Access Compliance Report

Public Rights-of-Way

(Curb Ramps)

Intersection ID: 29679	Main Street: CAMERON_CREEK_DR	Cross Street: SANDY_RIDGE_LN	Location:	N
ADA ID: 9965A5271E8D	Ramp Type: BlendTrans1	Initial Pass/Fail: Fail	Overall Compliance: No	Severity Score: 8.75
Codes/Mitigation Info/Possible Solution		Field Measurements/Component Compliance

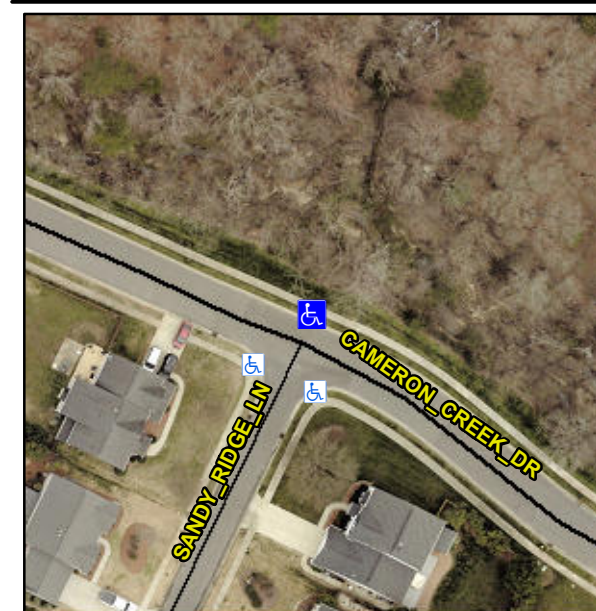
Not Found, R304.5.1

Compliance	Description	Data	Compliance	Description	Data
N/A	Ramp Length (in)	49.0	Yes	BlendTrans Slope (%)	4.3
No	Ramp Width (in)	47.0	Yes	BlendTrans XSlope (%)	1.8
N/A	Flare Type LT	N/A	N/A	Flare Type RT	N/A
N/A	Flare Slope LT (%)	N/A	N/A	Flare Slope RT (%)	N/A
N/A	Flare Traversable LT?	N/A	N/A	Flare Traversable RT?	N/A
N/A	Landing Length (in)	N/A	N/A	DWS Provided?	N/A
N/A	Landing Width (in)	N/A	N/A	DWS Contrast?	N/A
N/A	Landing Slope (%)	N/A	N/A	DWS Length (in)	N/A
N/A	Landing X Slope (%)	N/A	N/A	DWS Full Width?	N/A
N/A	Landing Curb? (Y/N)	N/A	N/A	DWS Offset (in)	N/A
N/A	Shared Landing?	N/A			
N/A	Gutter Ponding?	N/A	N/A	Gutter Slope (%)	N/A
N/A	Gutter Lip Ht (in)	N/A	N/A	Gutter X Slope (%)	N/A
N/A	Painted X Walk1?	No	N/A	Painted X Walk2?	N/A
	X Walk 1 Direction	To S		X Walk 2 Direction	N/A
	X Walk 1 Width (in)	N/A		X Walk 2 Width (in)	N/A
	X Walk 1 Slope (%)	2.5		X Walk 2 Slope (%)	N/A
	X Walk 1 X Slope (%)	0.6		X Walk 2 X Slope (%)	N/A

N/A	Ramp inside XWalk1?	N/A	N/A	Ramp inside XWalk2?	N/A
	Road Slope (%)	0.6		Clear Space?	N/A
	Road X Slope (%)	2.5	N/A	Clear Space to XWalk (in)	N/A
N/A	Any Obstructions?	N/A	N/A	Storm Grate/Utility Hazard?	N/A
	Obstruction Type			Storm Grate/Utility Type	
		N/A			N/A
			Yes	Surface Condition? (G/P)	Good
			No	Curb Slope (%)	6.9

Remove & Replace Curb Ramp With Two New Directional Ramps or Equivalent.
